VILLAGE REVIEW BOARD AGENDA COUNCIL CHAMBERS, 85 UNION STREET TUESDAY, OCTOBER 21, 2014; 7:15 P.M.

**Draft Findings of Fact
6 Jordan Avenue
Request for Certificate of Appropriateness for Structural Addition and Alterations
Village Review Board
Review Date: October 21, 2014**

**Draft Findings of Fact
38 Cumberland St
Request for Certificate of Appropriateness for Structural Alteration
Village Review Board
Review Date: October 21, 2014**

FRONT ELEVATION

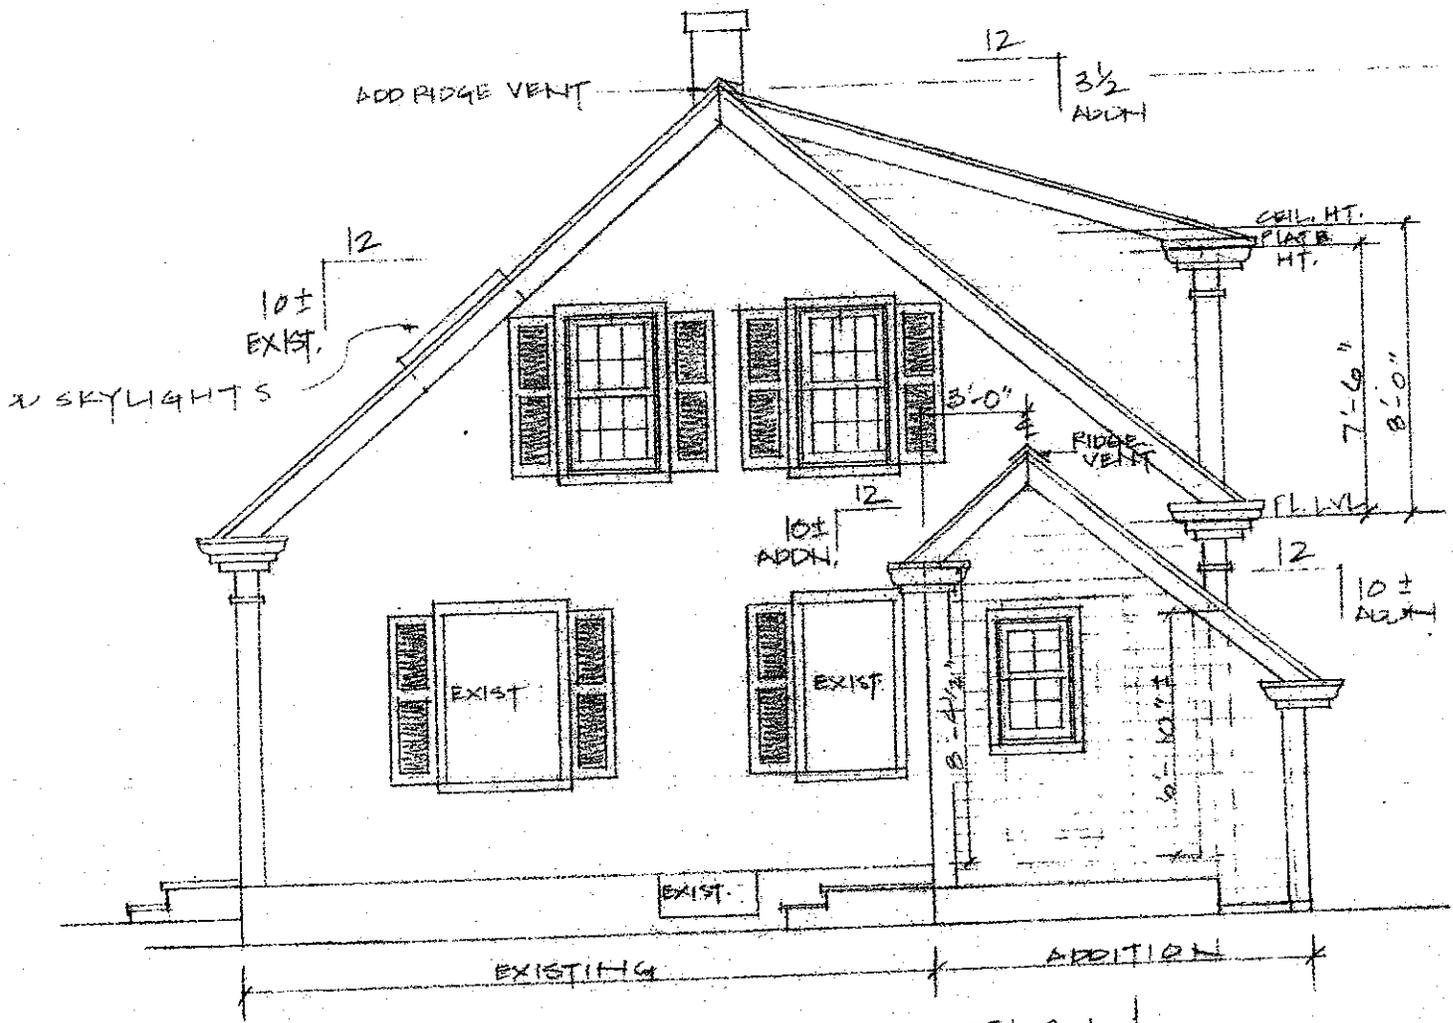
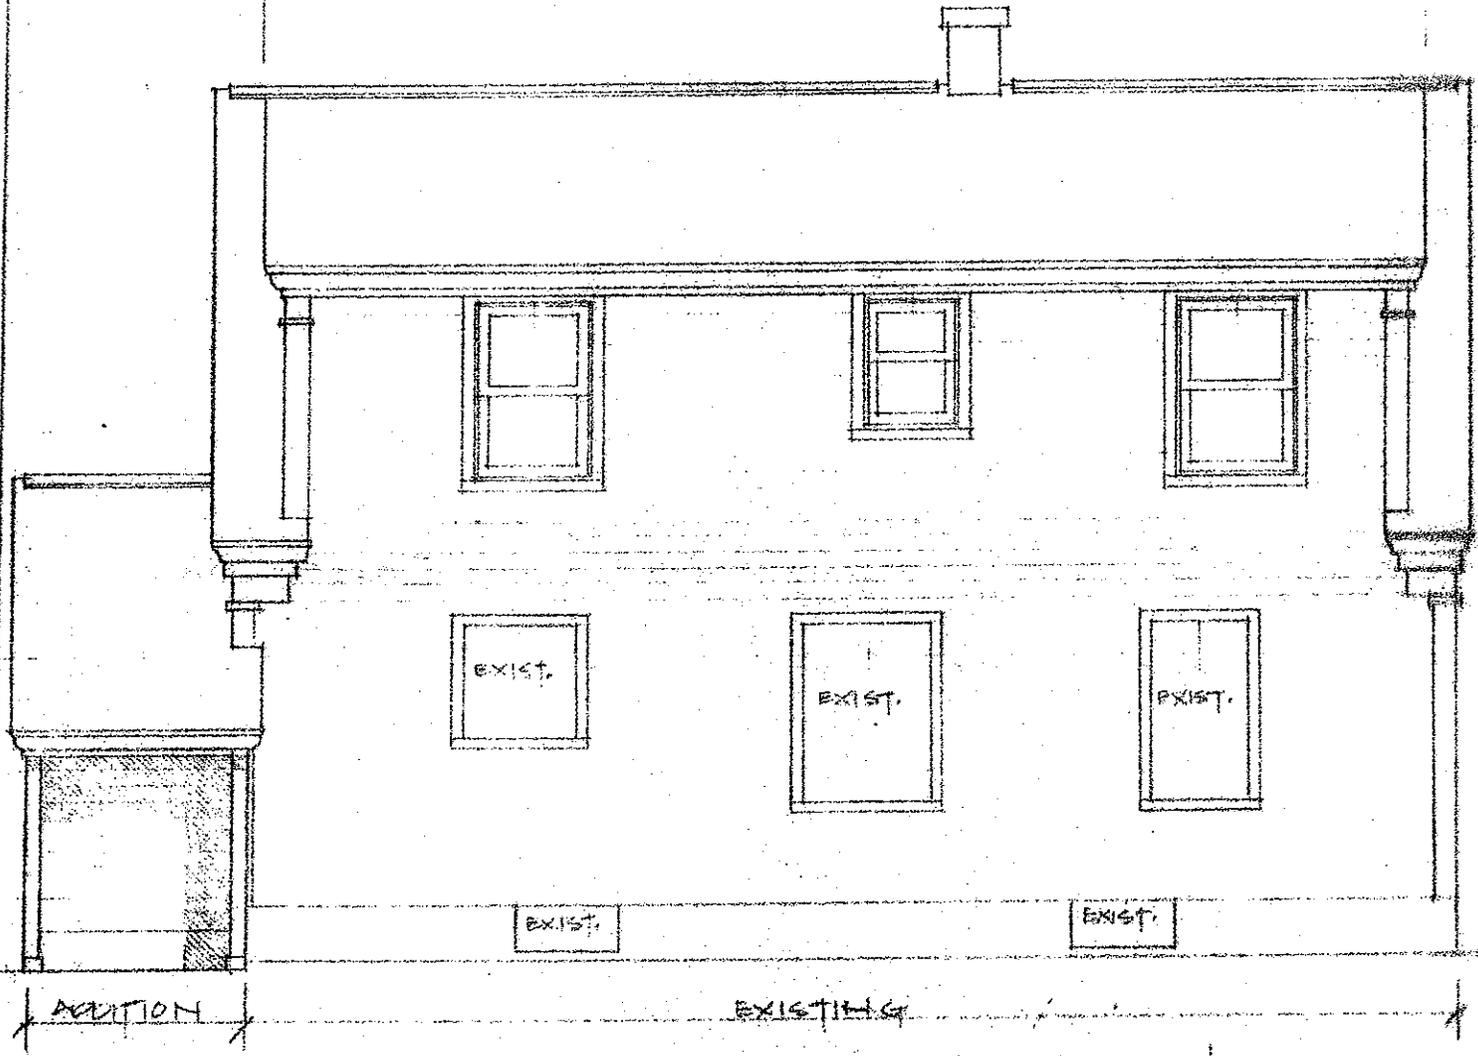
b. To install two “fresh air” skylights on the front roof centered to the first floor windows.

a. Any additions or alterations shall be designed in a manner to minimize the overall effect on the historic integrity of the contributing resource. *As proposed the mudroom location utilizes an existing doorway near the west rear corner of the structure and will be constructed of like materials, minimizing the overall effect on the historic integrity of the contributing resource. The installation of roof skylights also minimizes the overall effect on the historic integrity by their coordinated placement with the first floor windows*

b. Alterations shall remain visually compatible with the existing streetscape. *Alterations are visually compatible with the existing streetscape. However, due to TR4 zoning district dimensional standards it is questionable whether it can be constructed. It appears that the existing structure and improvements exceeds the maximum impervious coverage standard of 35%. Such a determination will be made as part of the building permit approval process.*

Motion 2: That the Board approves the Certificate of Appropriateness for the construction of mudroom addition and installation of 2 roof skylights at 6 Jordan Avenue with the following condition:

IMPROVEMENTS FOR EAST FACADE
 LINCOLN BUILDING • MAINE ST.
 1/8" ≈ 1'-0"
 D.R.A.
 25 FEB 2014

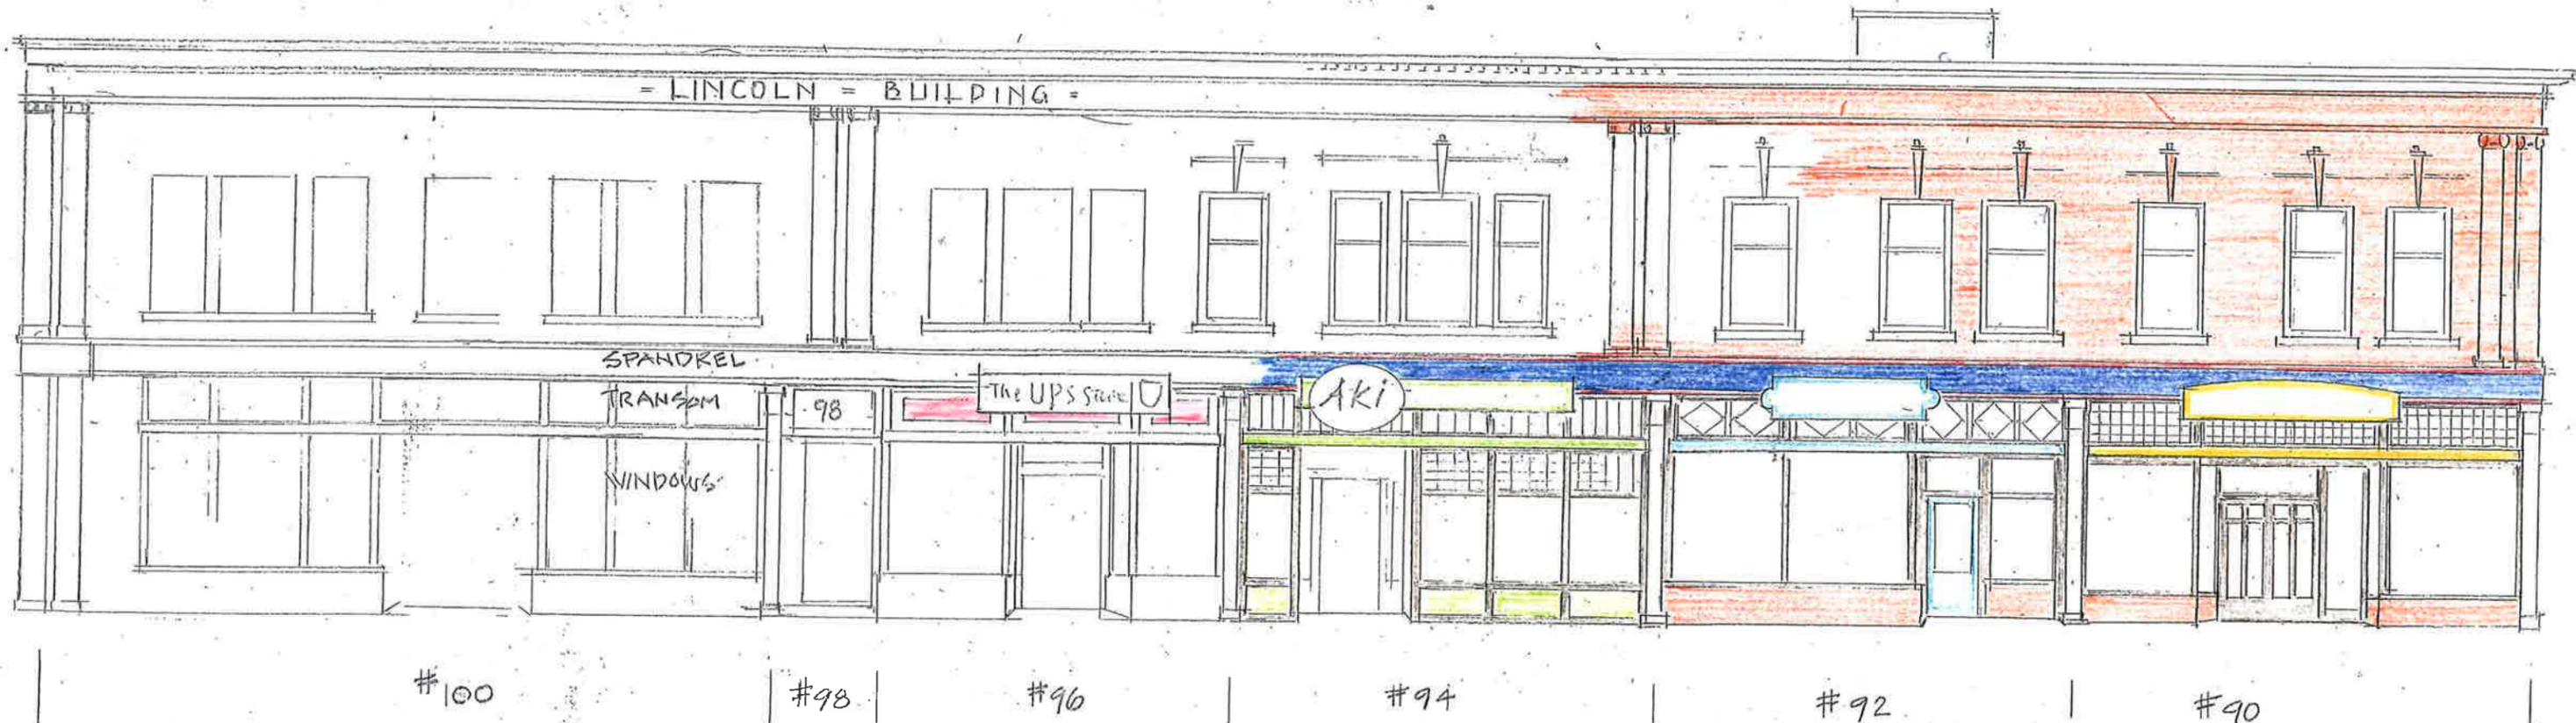
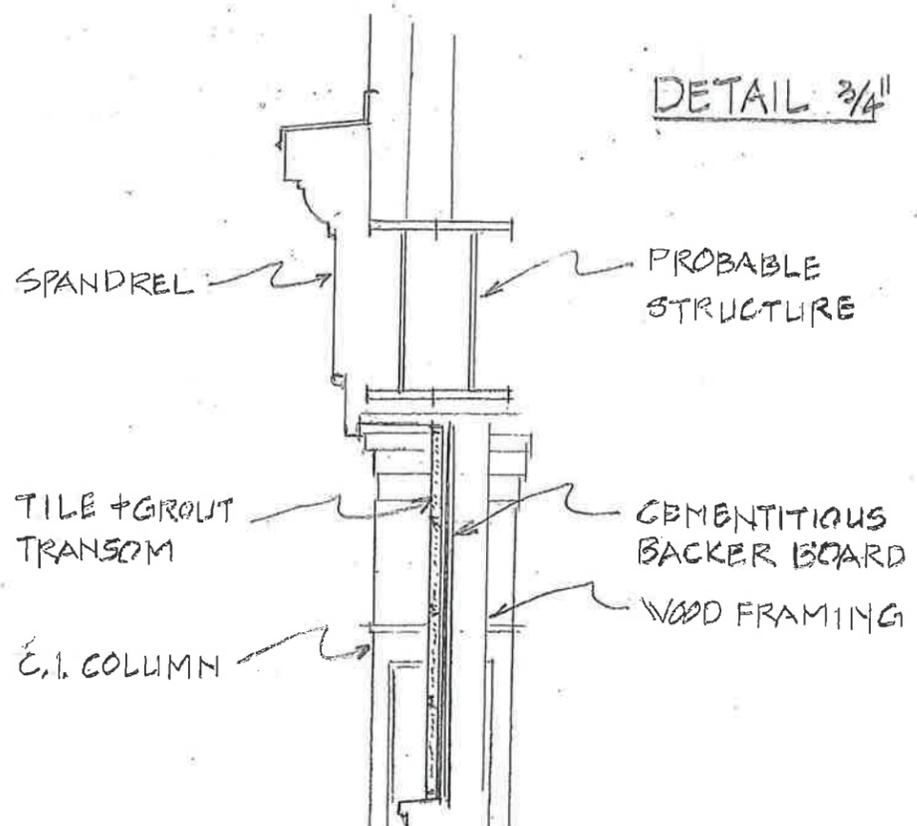
Remove
more windows
over 2+- feet
& add another
window

Remove ugly plywood

Signs reloc.

3. That the treatment of the individual tenant spaces, and the façade as a whole, be consistent with the drawing entitled "Improvements for East Façade", dated 2/25/2014, with the following exceptions: a) that any new signage be of a consistent size and not extend above or below the spandrel and, b) that the configuration of the transom windows be uniform across the facade.

4. That the AKI sign be relocated to align with the building sign band as shown in the 2/25/2014 drawing and noted in your response to committee comments.
